## **Report of Geotechnical Engineering Evaluation**

Proposed Multifamily Development  
Venetucci Boulevard at South Academy Boulevard  
Colorado Springs, Colorado

October 11, 2024

PSI Project 05322879

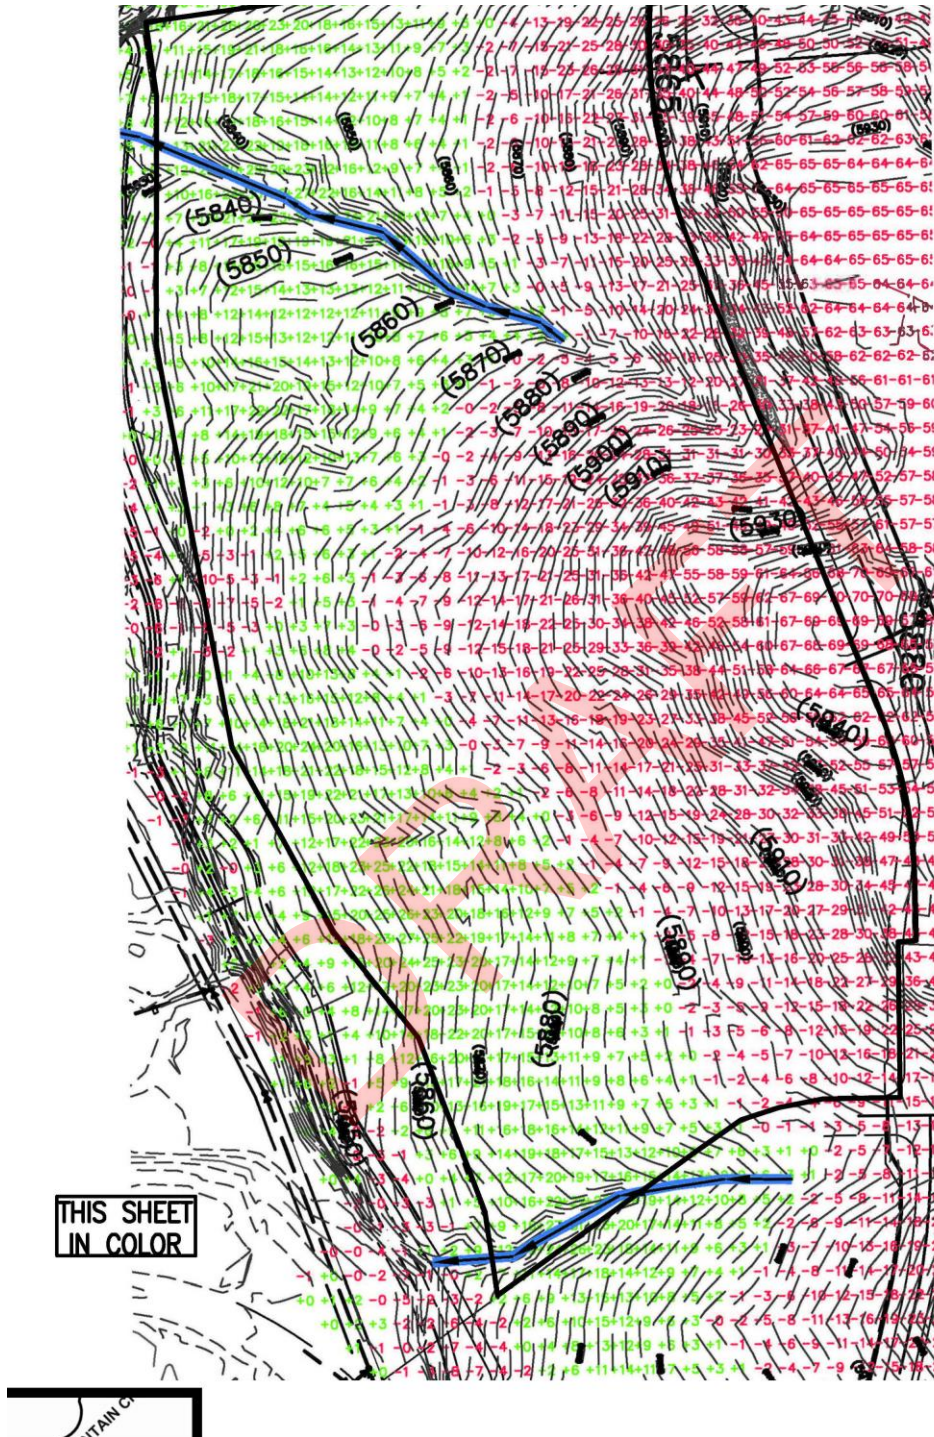
please update to  
meet County Code  
requirements of  
Section 8.4.9 and  
those of the ECM

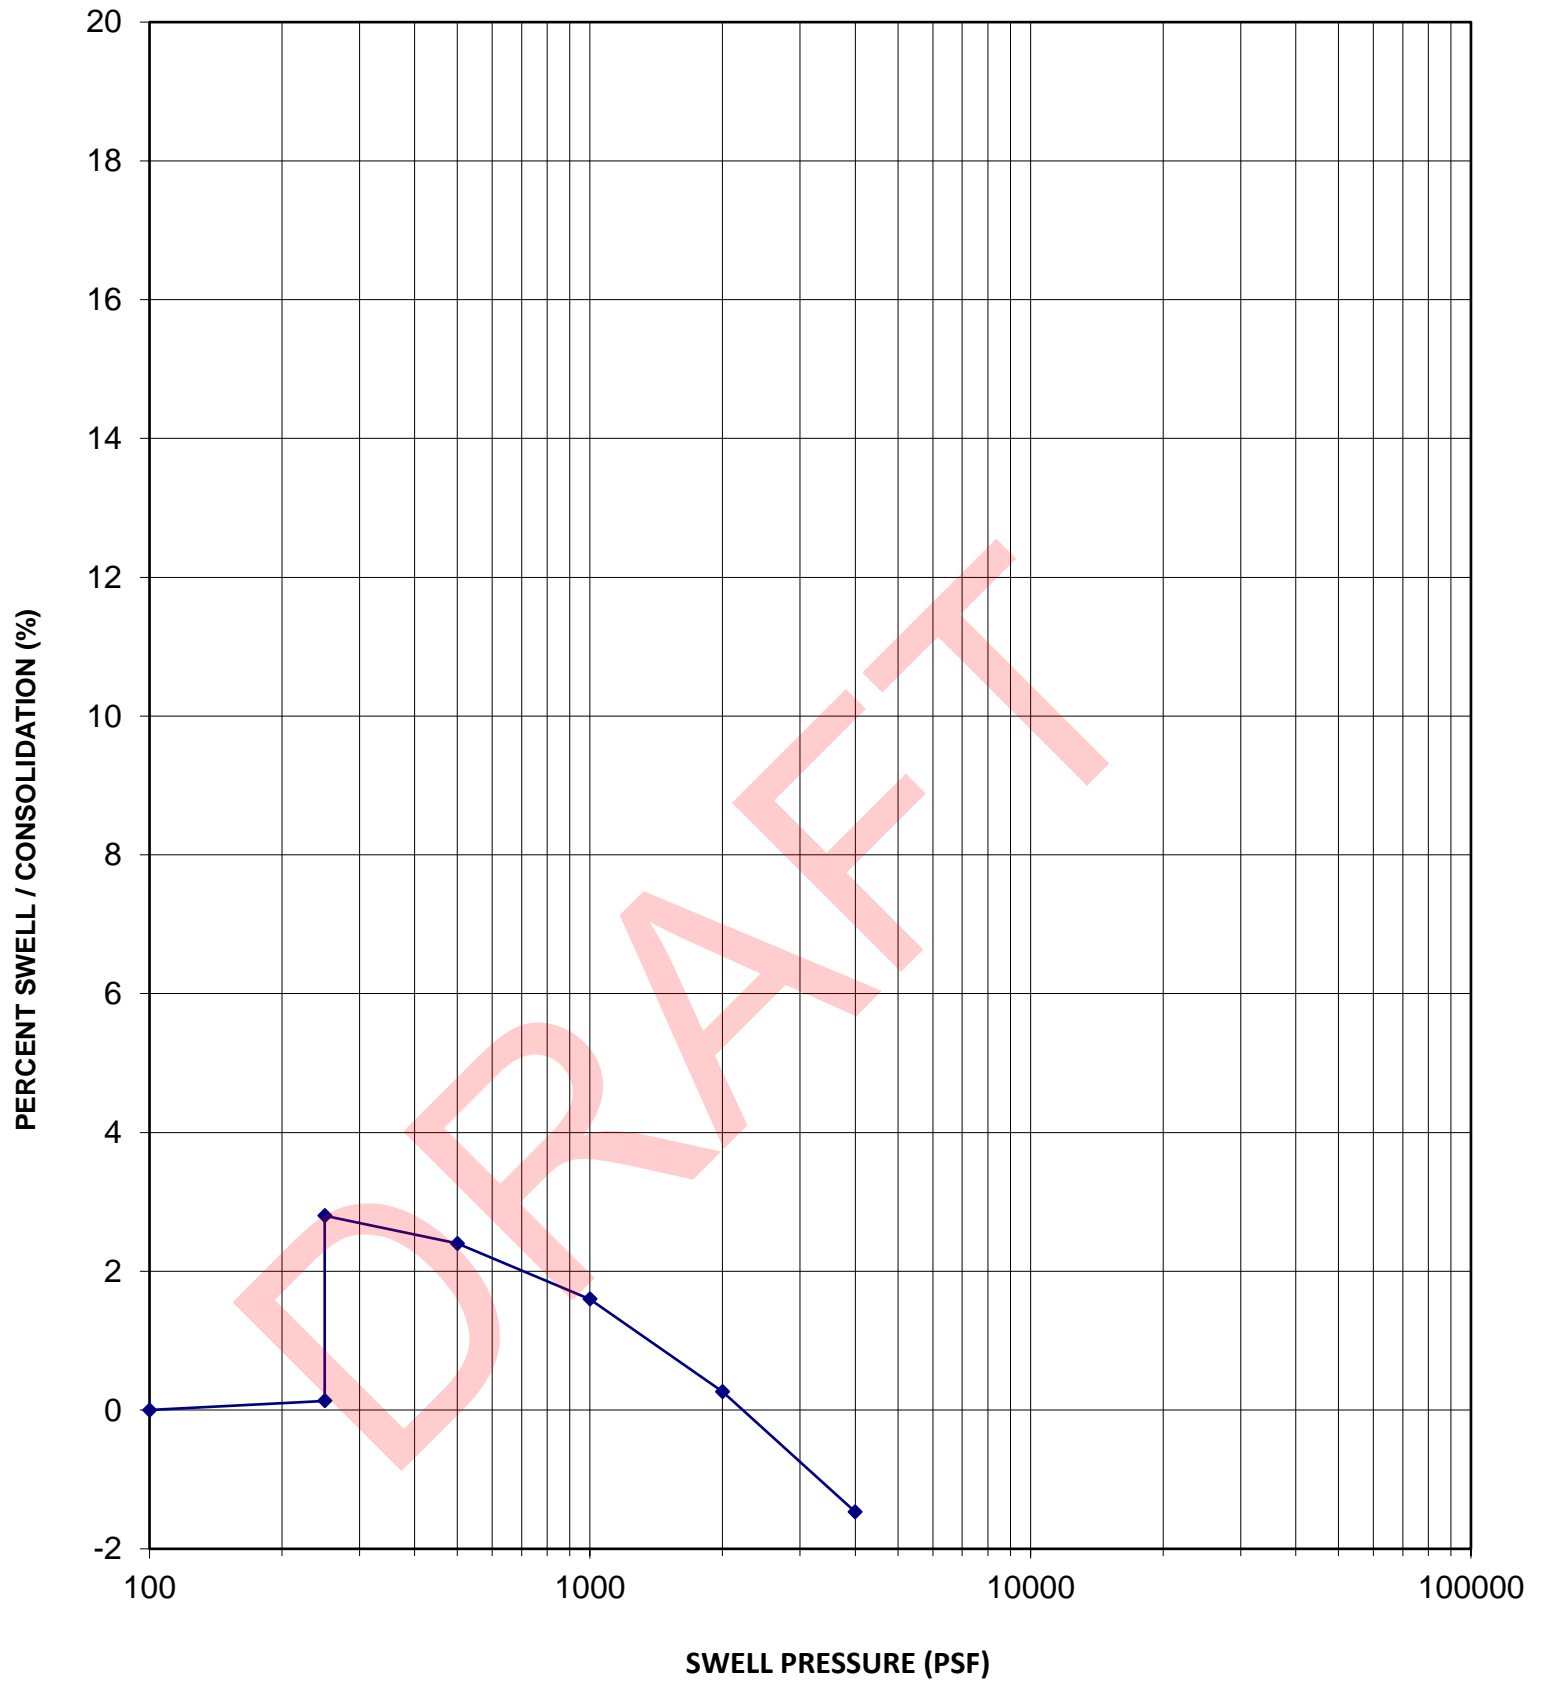
groundwater boring results include

TRes Venetucci Multifamily	JOB NO.	5322879
	SWELL - CONSOLIDATION TEST	FIGURE NO.	0

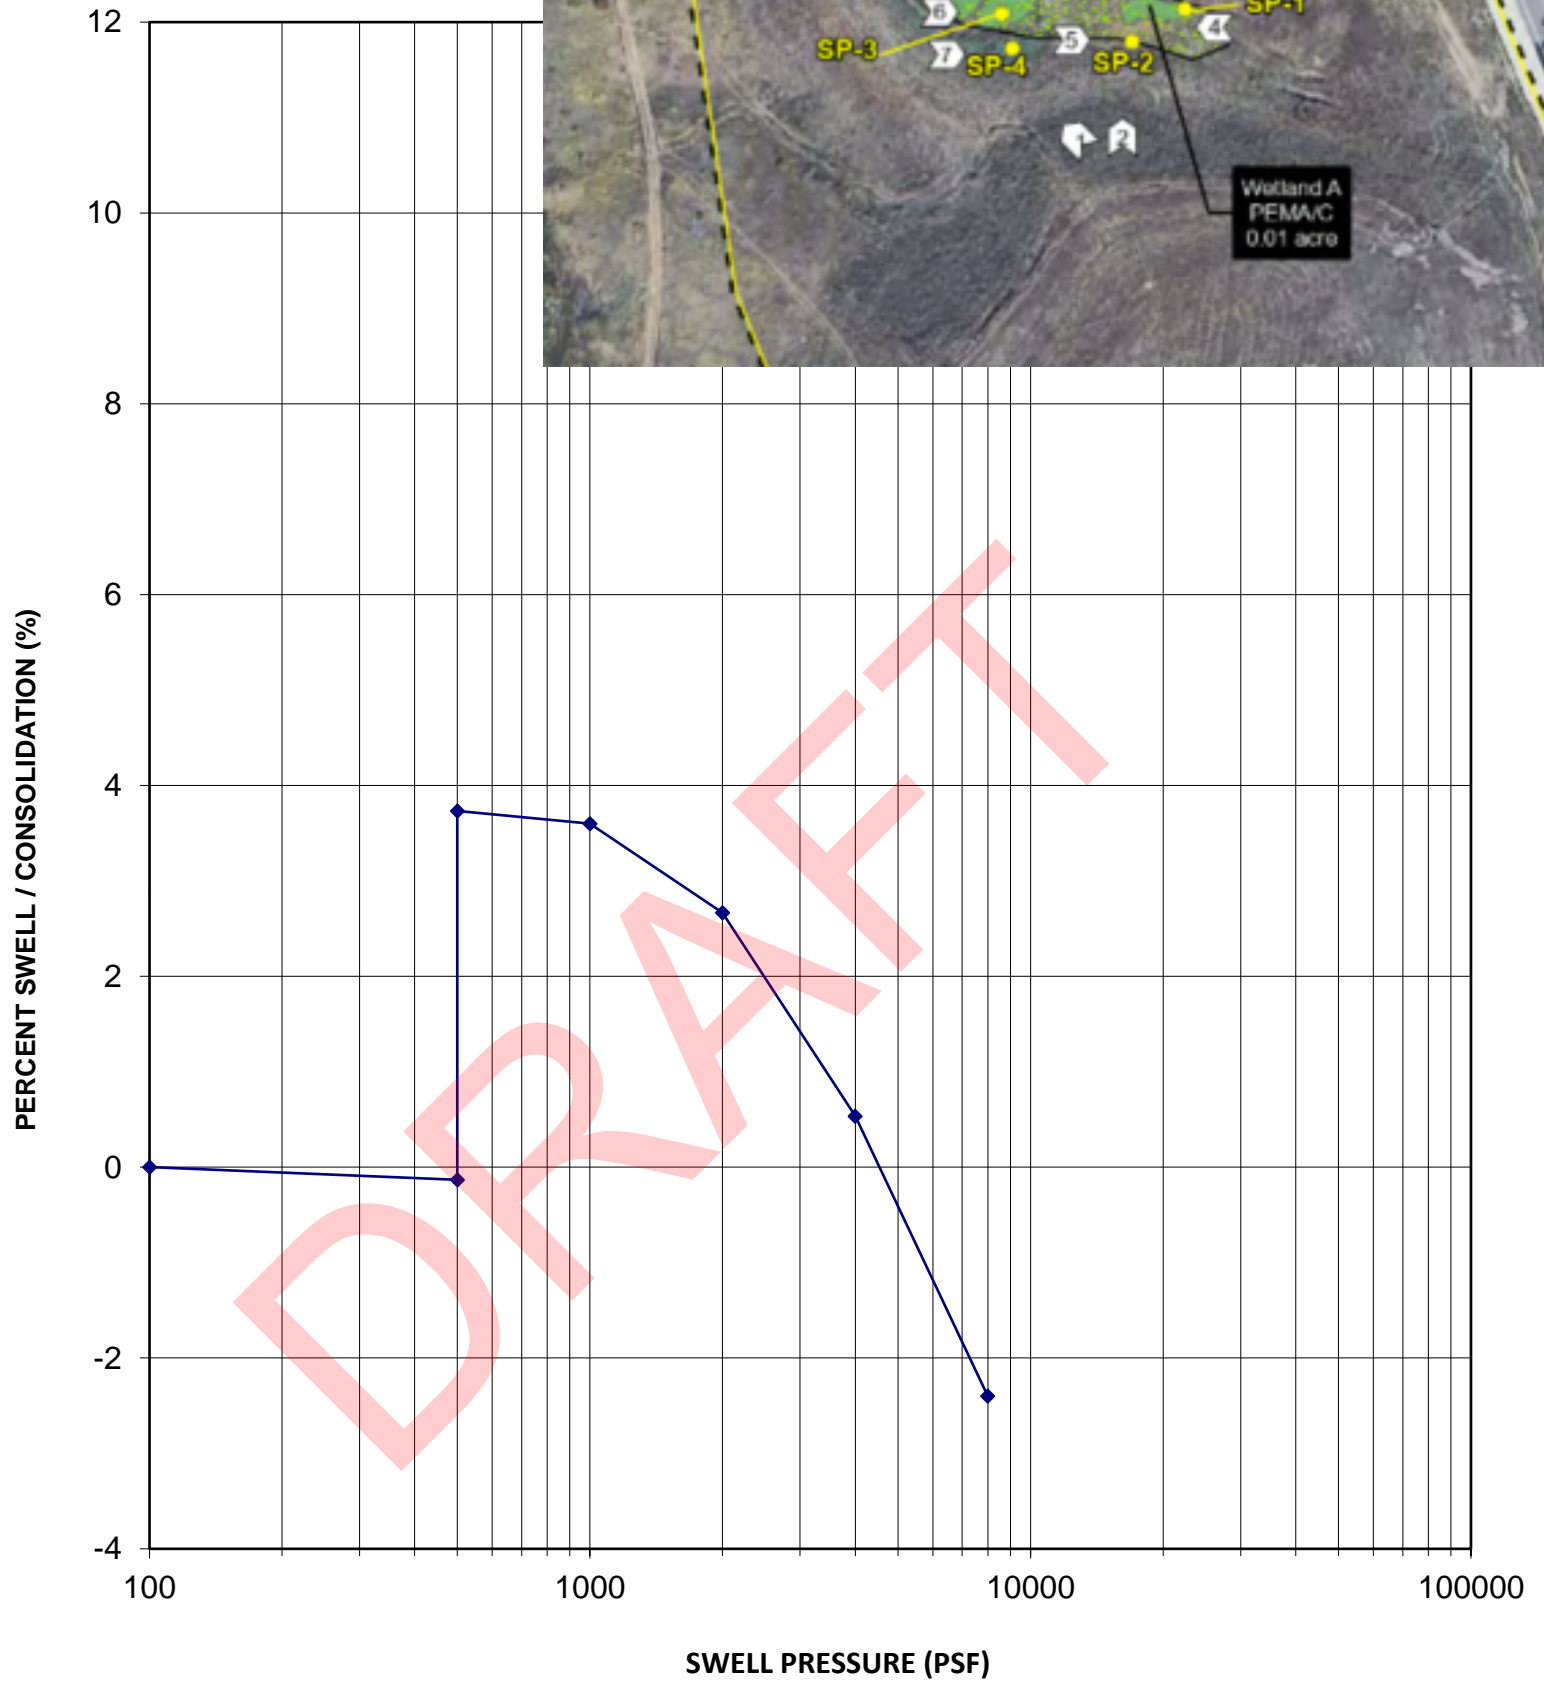
hazards shall be mapped and mitigation method identified

Provide a map of the site with the constraints and hazards identified
